Statement No. 781

**STATEMENT THAT A PROPOSAL MAY BE IMPLEMENTED
(PURSUANT TO THE PROVISIONS OF THE
ENVIRONMENTAL PROTECTION ACT 1986)**

**DREDGING AT FINUCANE ISLAND,
BHP BILLITON RGP5 PROJECT, PORT HEDLAND**

Figure 1 - Dredging at Finucane Island – key proposal components

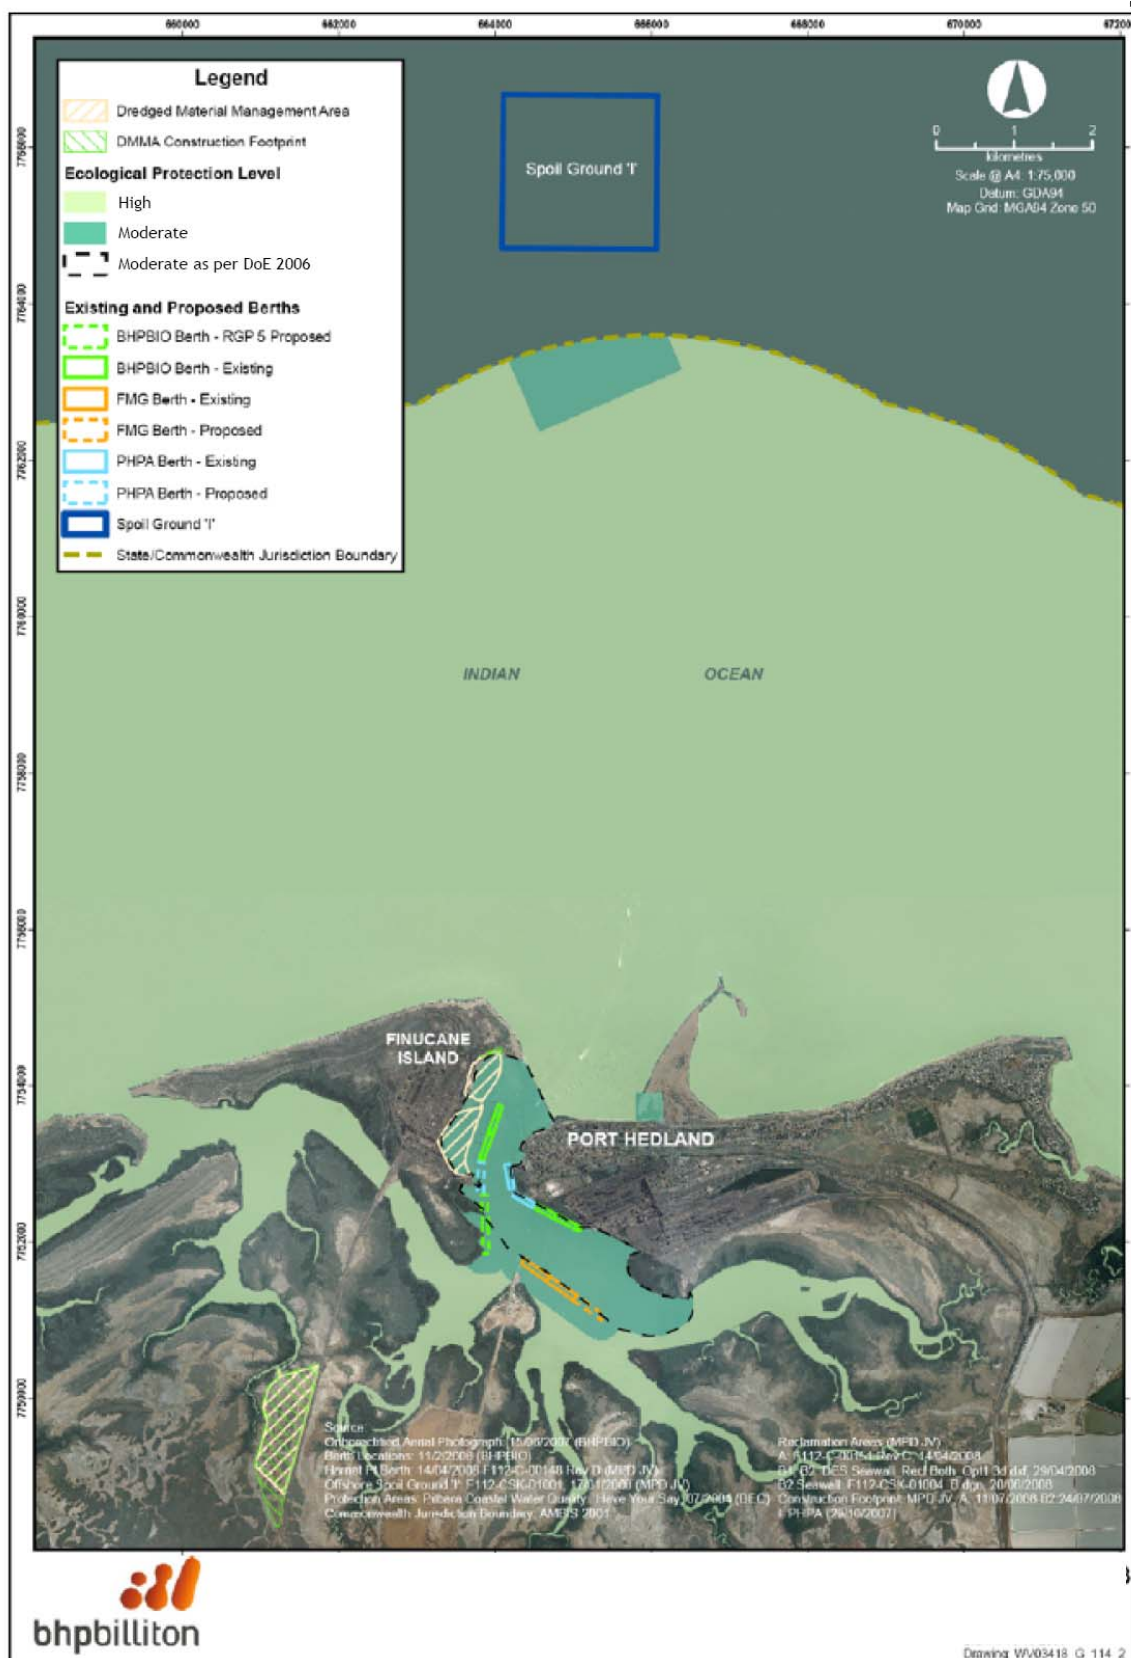
- Increase the height of dredged material management area (DMMA) B1 from 17 metres Australian Height Datum (mAHD) up to 30 mAHD (not including vegetation).

Figure 3: Existing access track to Harriet Point.

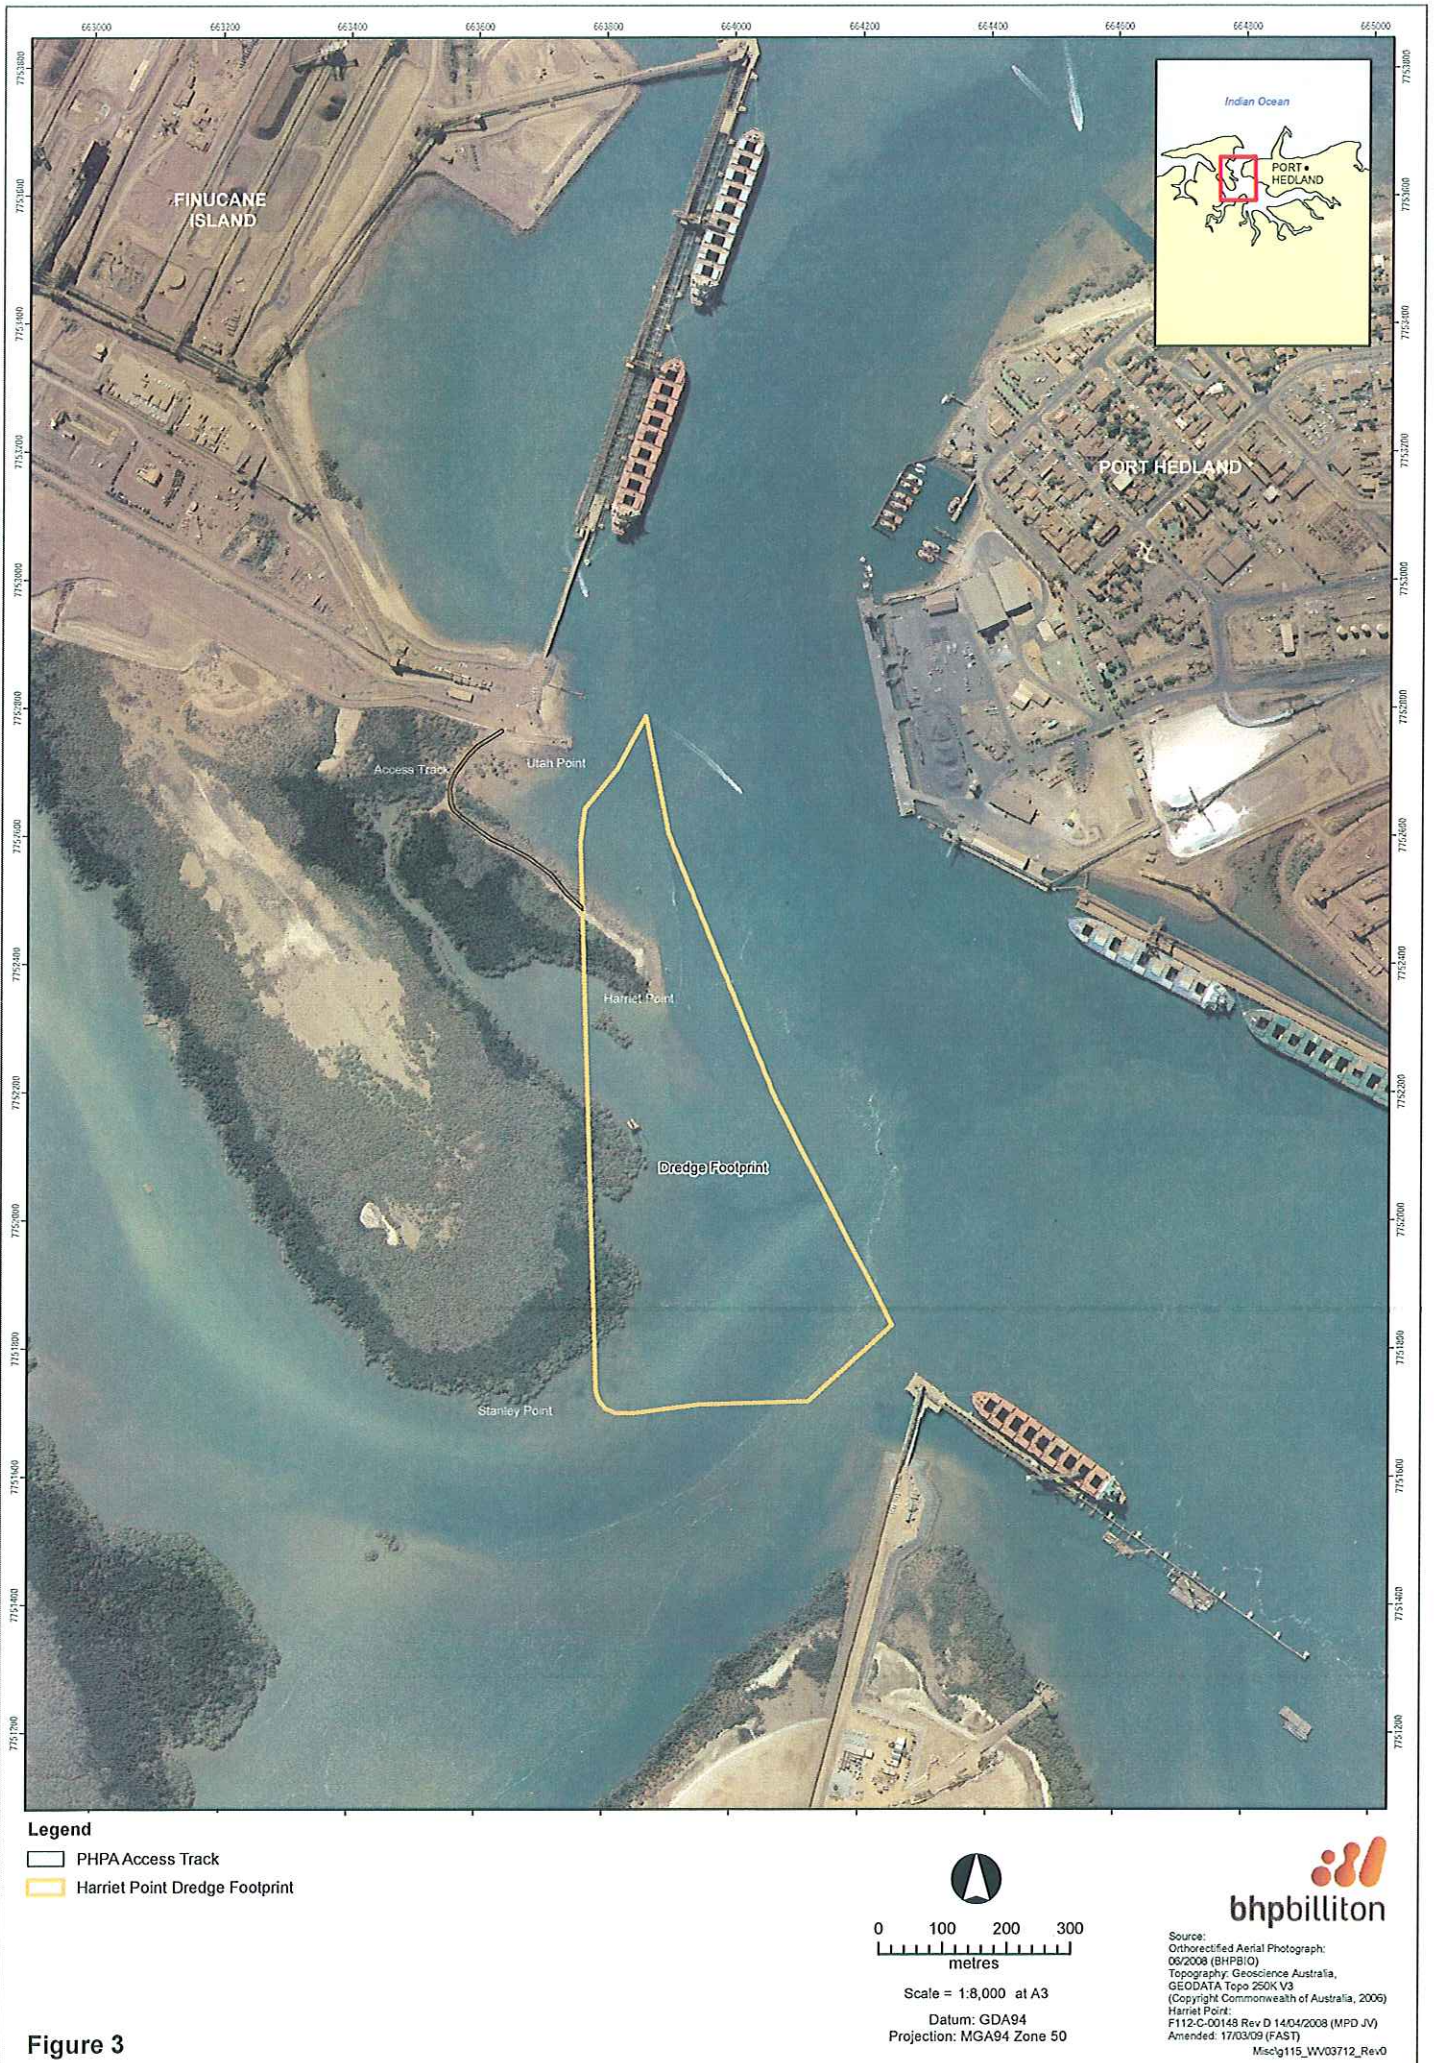
Change: Alternative access to remove mangroves (as shown on Figure 3).

Remove mangroves at the south-eastern tips of Harriet Point and Stanley Point using land-based equipment. Access south-eastern tip of Harriet Point via an existing track and the south-eastern tip of Stanley Point via the installation of a temporary causeway, within the approved dredging footprint, between Harriet Point and Stanley Point.

Figure 4 – RGP5 Dredge footprint area

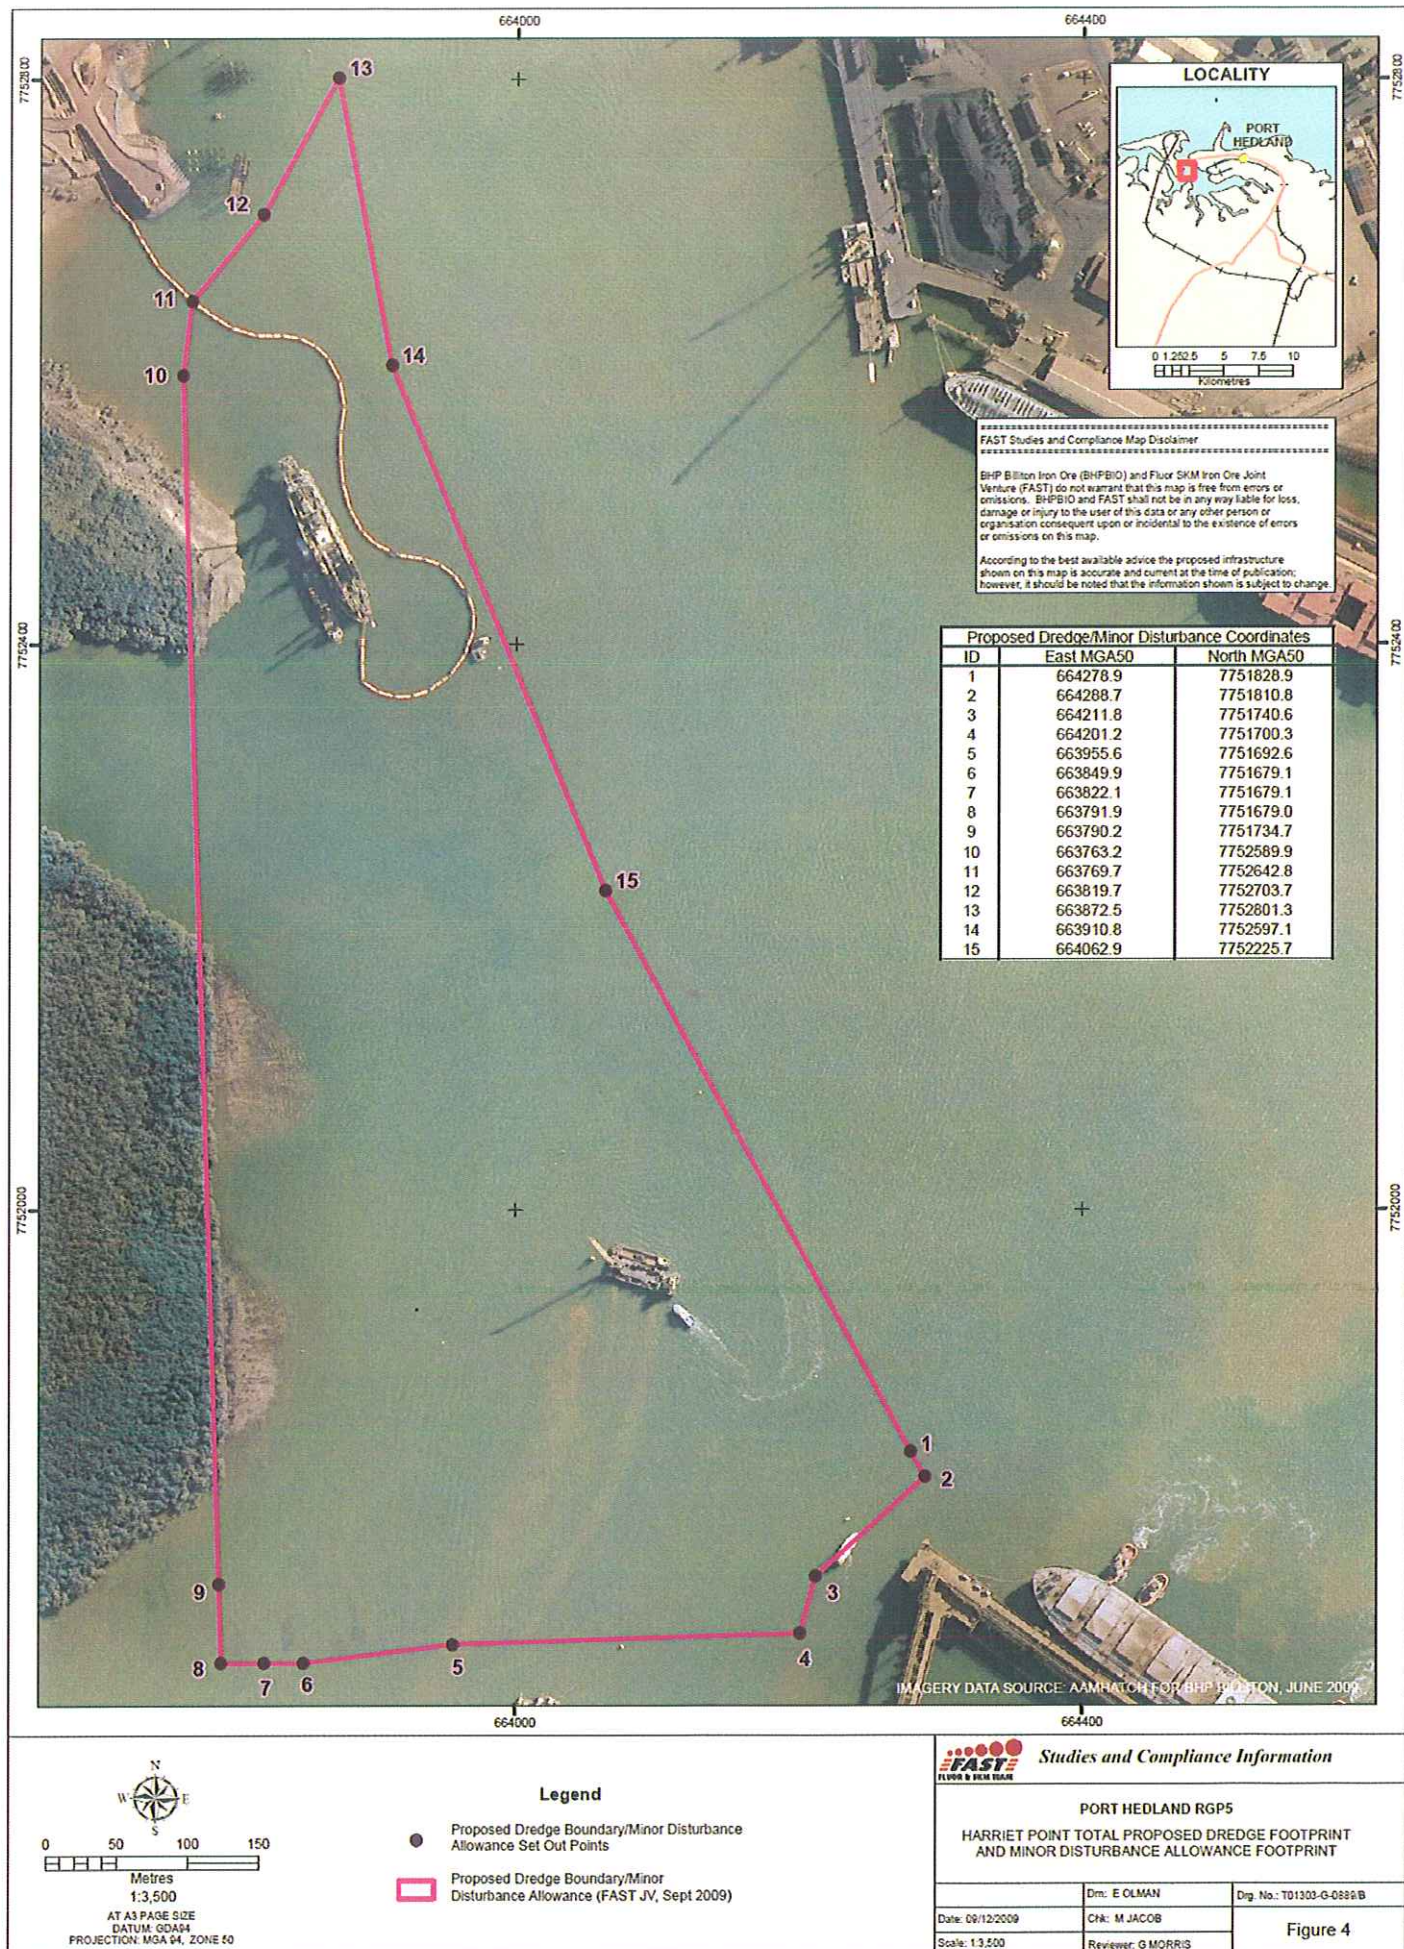
Change: Increase the size of the dredge footprint by three hectares to 28 hectares, and increase volume of material to be dredged by 50,000 cubic metres to be 3,950,000 cubic metres (as shown on Figure 4).
